C S Stokes and Associates Limited

Flat 45 Grenfell Tower Grenfell Road London W11 1TQ

Subject: The flat entrance door

Flat Entrance door

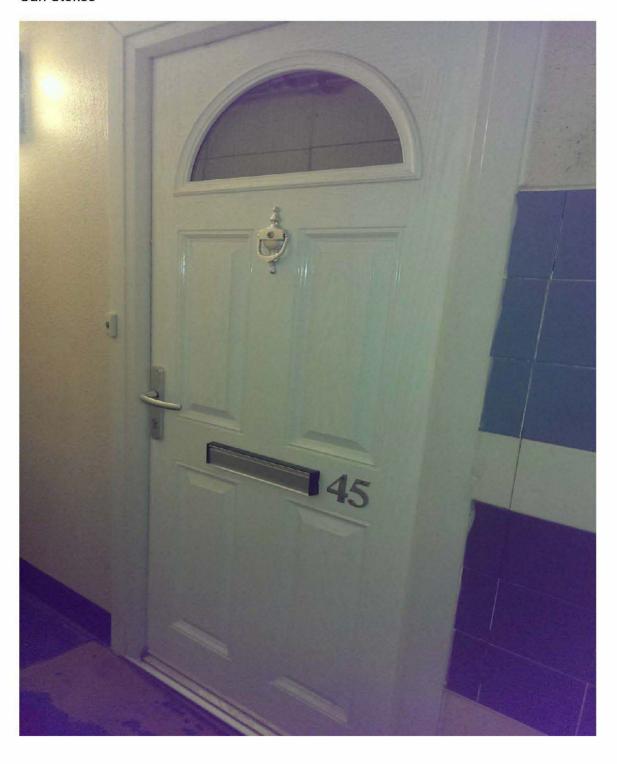
I looked at this flat entrance door yesterday, Monday the 27th July, the occupant allowed me to inspected this flat entrance door from both sides of the door, please see the photograph of this flat entrance door below.

This is one of the certified fire rated doors fitted by "Masterdor" as part of the flat entrance door replacement programme, the glazing in the doors fan light area is Georgian wired fire rated glazing on the inner face.

When I inspected this door yesterday the door lock is slightly out of alignment, it appears that when whoever attempted to force open this door that some slight damage has occurred. I noted that the concealed self closing device is missing from this door, two additional bolts have been fitted to the rear of the door and the inner part of the letter box is missing. Please see the relevant photographs below. There is no damage to the doors surface and no holes etc in the doors face/surface.

I believe that this door is still fully functional as a fire rated door, but adjustments should be made to the door so that the lock a lines correctly and a new inner part of the letter box should be fitted or the letter box replaced. The police officers report indicates that they recommend that a fire rated letter bag is fitted on the inner face of the door. This could be fitted at the same time as or in replace of the existing letter box. I would recommend that the door manufactures are consulted regarding the fitting of any items of additional door furniture to this certified fire rated door. This is in case any work undertaken on or to the door by non qualified persons or additional features fixed to the door invalidates any fire rated certification of the door.
